HALE Hale Products, Inc. Service Bulletins					
Bulletin#:	SB74	Re	evision#:	1 Date	e: 3/2/2004
Product Type Covered: Hale Pump X Hurst Tool Lukas Tool Product Covered:					
1.0 and 2	.5 V-Series	Foam Systems			
Problem S	tatement:				
1		led Upside Dov and Subseque	wn. This Can nt Failure.	Cause Reverse	Polarity
Written by:	ritten by: Paul Wentz		Date:	3/2/2004	
Approved by: Micha		el A. Laskaris, PE			
Product Manager:		Dominic Collet	tti		
Customer Service Designee:		Doug	Balco]

Body of the Bulletin

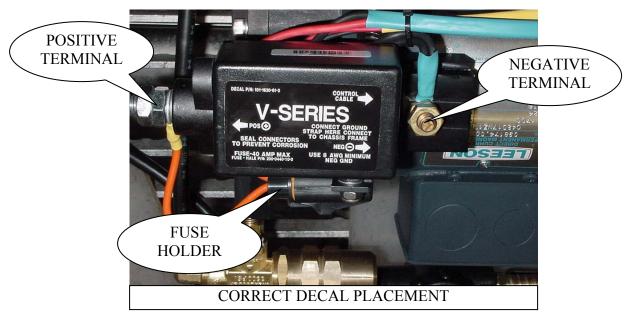
During recent production of 1.0 and 2.5 V-Series foam systems the system connection decal was placed on a motor driver box upside down causing the installer to incorrectly apply voltage to the motor. While we only have three recorded cases of this event out of hundreds of units, please be careful and note that the ground connection is tied directly to the metal heat sink bar.

Making reverse polarity connections to the motor will cause an immediate failure to the system.

The photo below identifies the correct terminals. Using the photo below and the installation manual provided (Hale P/N 029-0021-55-0) as guides, check units currently in stock to make sure the decal is installed correctly. The decal part number is 101-1630-61-0. Hale will provide replacement decals upon request.

Units that are installed with the incorrect wiring will experience an immediate failure. These units should be returned to Hale for replacement.
